# **Product Change Notification**

Change Notification #: 119084-00

Change Title: Intel® Wireless-AC 9462, 2230, and Intel®

Wireless-AC 9461, 2230, SKUS

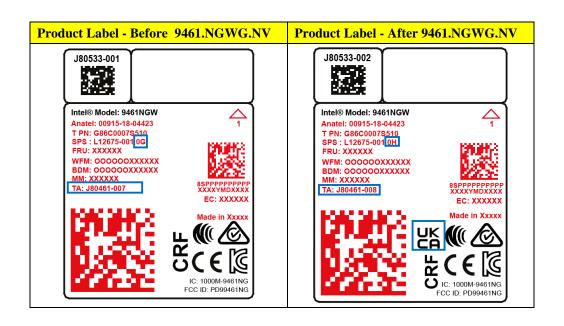
7. The Intel tracking revision will be changed on the following products.

<b>Product Code</b>	Before	After	
9461.NGWG.NV	0G	0H

8. Product TA# dash up.
